EB-2016-0105

**Thunder Bay Hydro Electricity
Distribution Inc.**

OEB Staff Compendium

Ontario Energy Board Staff – Distribution System Plan Cross Examination

Figure 5.2.3-2 Historical SAIDI Performance

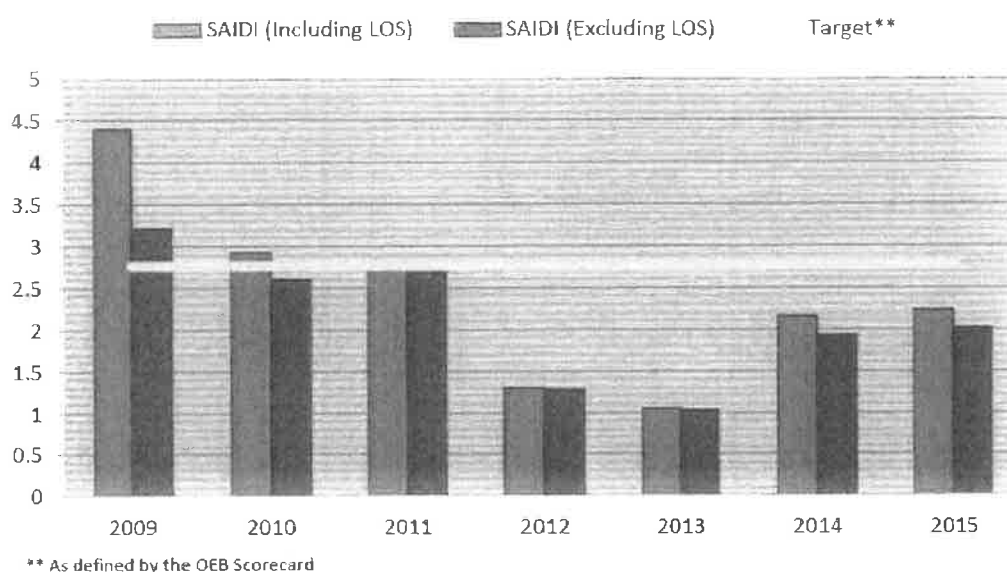
- Please explain the reasons for the comparatively high SAIDI in 2009.
- Please explain the reasons for the step improvement in SAIDI from 2011 to 2012.
- Please explain the reasons for the increase in SAIDI from 2012 & 2013 to 2014 & 2015.

b) 2011 to 2012 had less significantly sized outages due to fewer weather related outage events.

c) 2012 and 2013 had less significantly sized outages due to fewer weather related outage events.

2014 and 2015 could be considered a more "normal" year with regard to the number of significant weather related outage events.

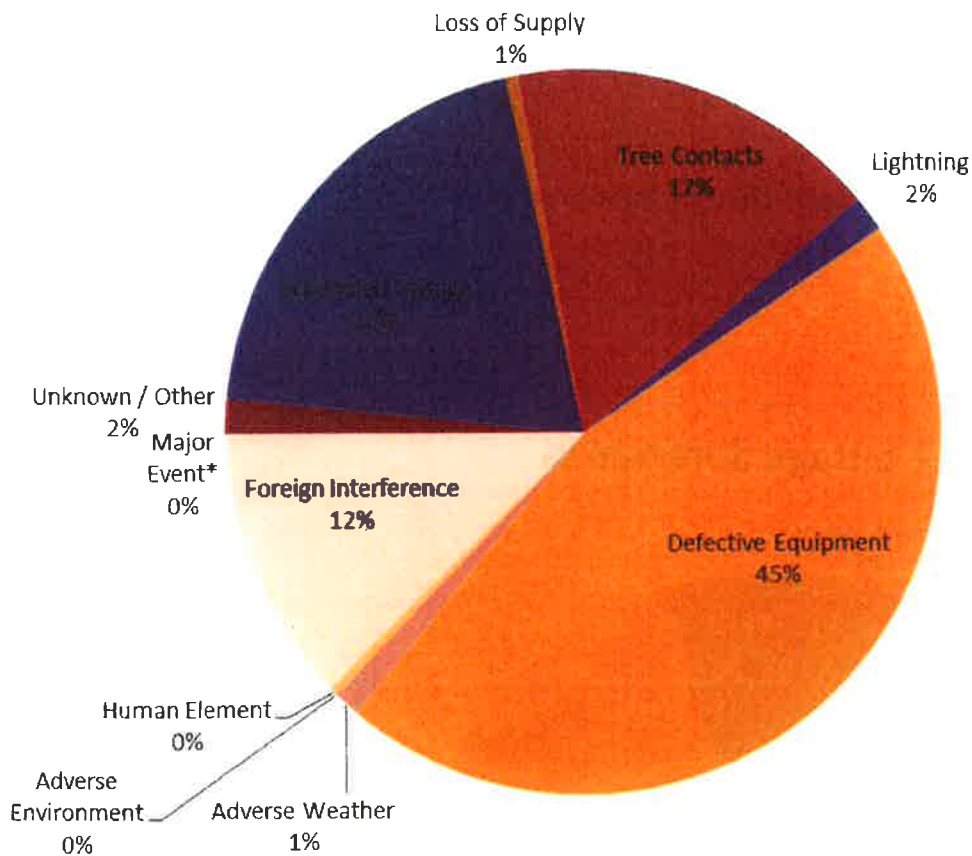
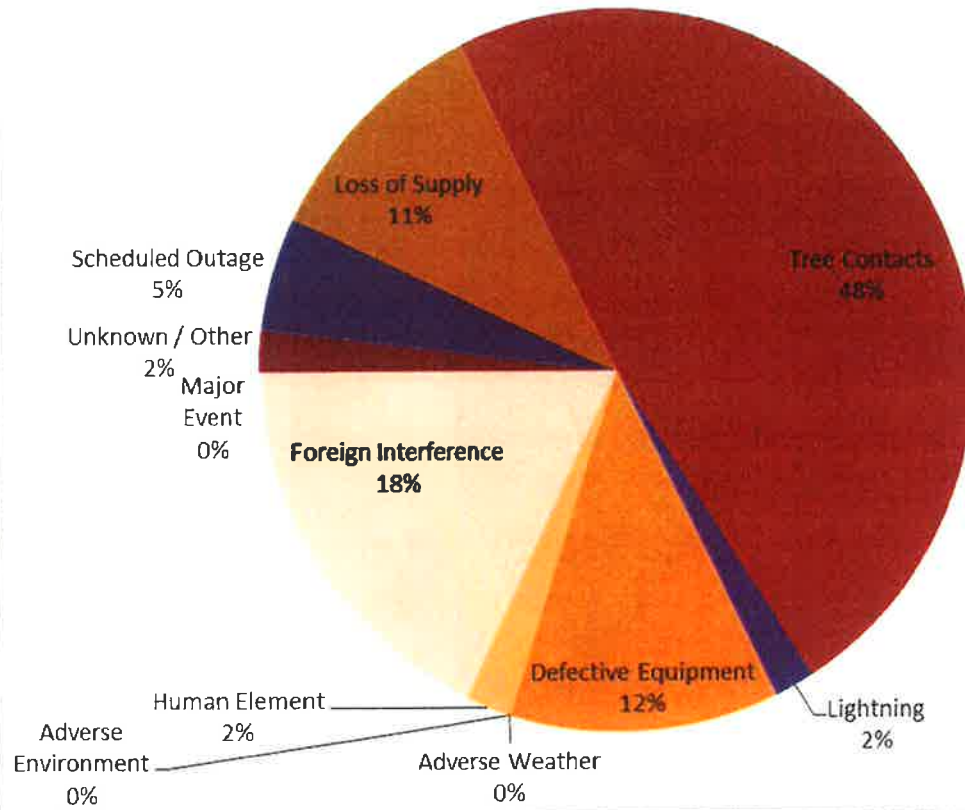
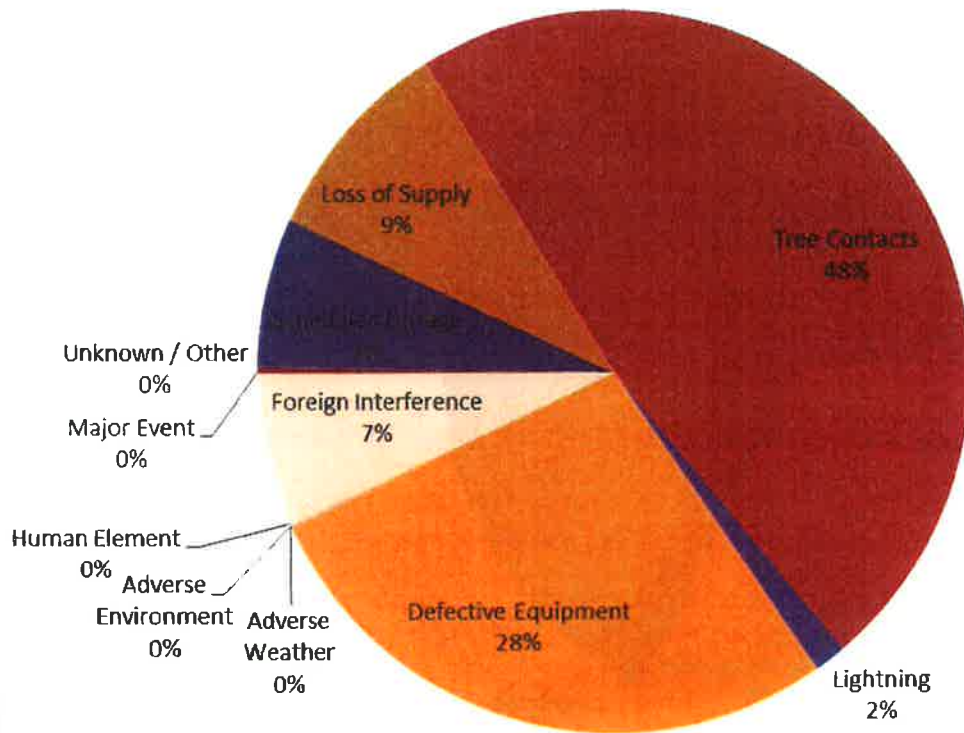
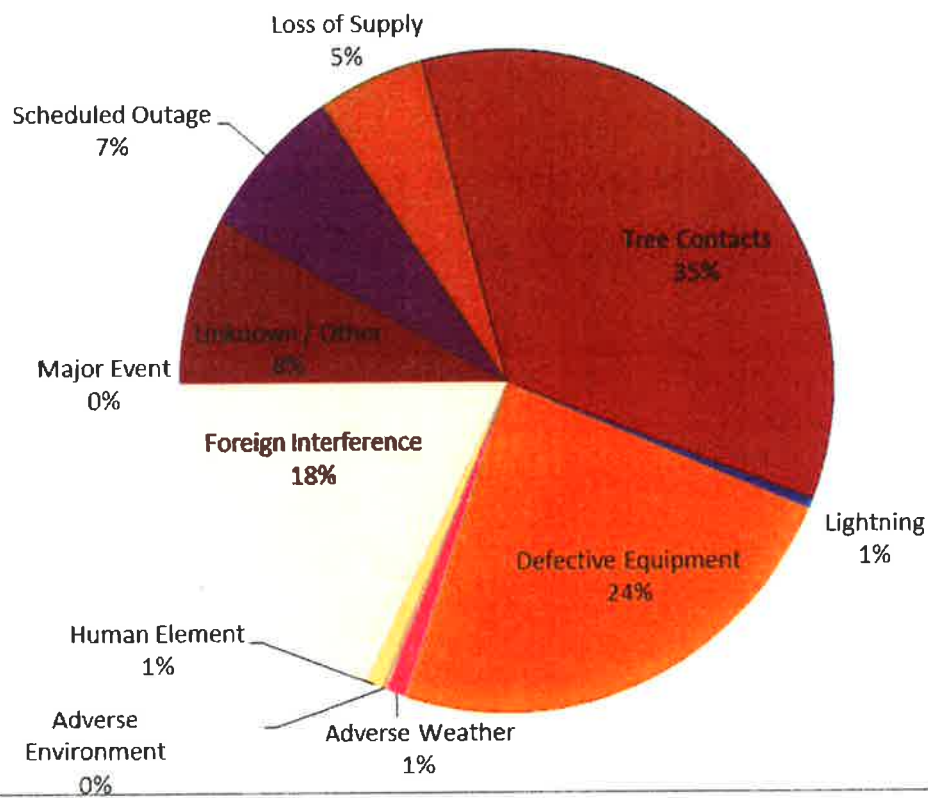
- Figure 5.2.3-5 Outage Causes by Duration: Please provide Figure 5.2.3-5 separately for each of the following years: 2012, 2013, 2014, and 2015.
- Please provide a Figure that shows the Outage Causes by Duration for 2016.

2013 outage duration %

2014 outage duration %

2015 outage duration %

2016 outage duration %

Figure 3 - TBHEDI's 10-Year FFAP

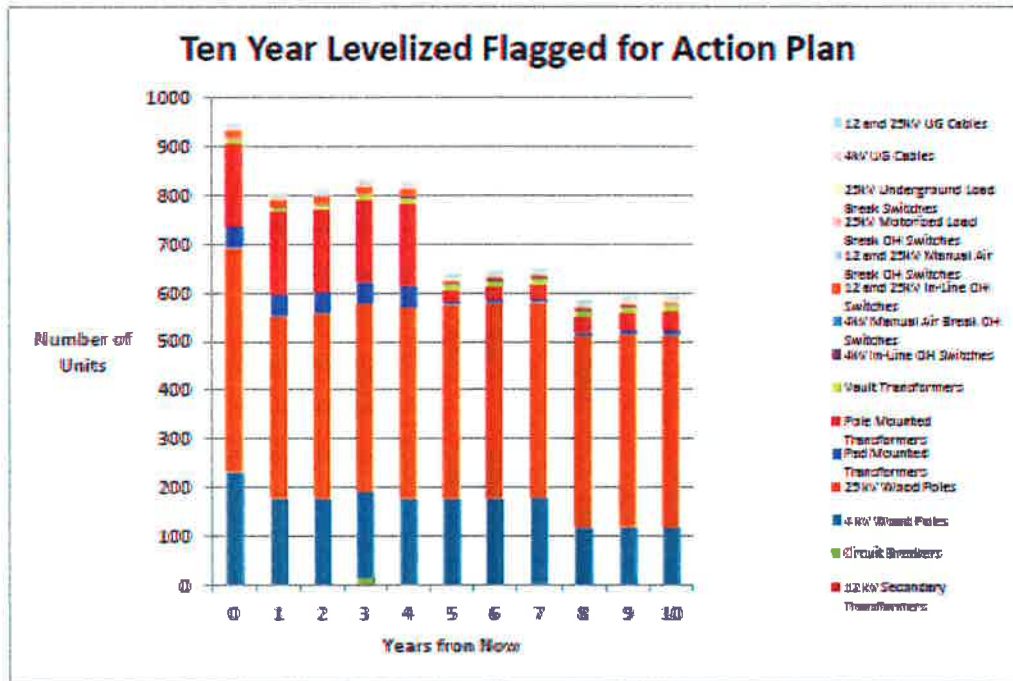
- Please explain the reasons for the significantly higher number of units flagged for action during the first five years (year 0 to 4) shown in Figure 3, and particularly the number of units in year 0. Please quantify the explanation, to the extent possible.

- Does the Flagged-for-Action Plan (FFAP) shown in Figure 3 incorporate the asset replacements forecast in the present filing? If not, please provide an updated version of Figure 3 that does incorporate the forecast replacements.

- What would be the anticipated reliability impacts of implementing a replacement program that was more evenly paced over the planning horizon shown in Figure 3?

- Please compare the FFAP with historical replacements for the 5 year period immediately prior to year 0 in Figure 3.
- Please explain the reasons for any significant (>10%) inter-annual unit flagged for action counts over the historical and planned horizons, by asset class.

- d) Please see below the historical replacements for the 5 year period immediately prior to year 0.

- b) The asset replacement forecast in the present rate filing incorporates FFAP is an input in representing condition driven replacement needs along with other drivers (see response to ER-Staff-79 a)) and not the other way around.
- c) Please see our response to ER-Staff-80 b)
- e) FFAP was developed for the first time in 2016 and represents condition based only replacement requirements. Historical replacements represent not only condition based replacements but also replacements for other reasons and, thus, should not be compared to the FFAP in the ACA.
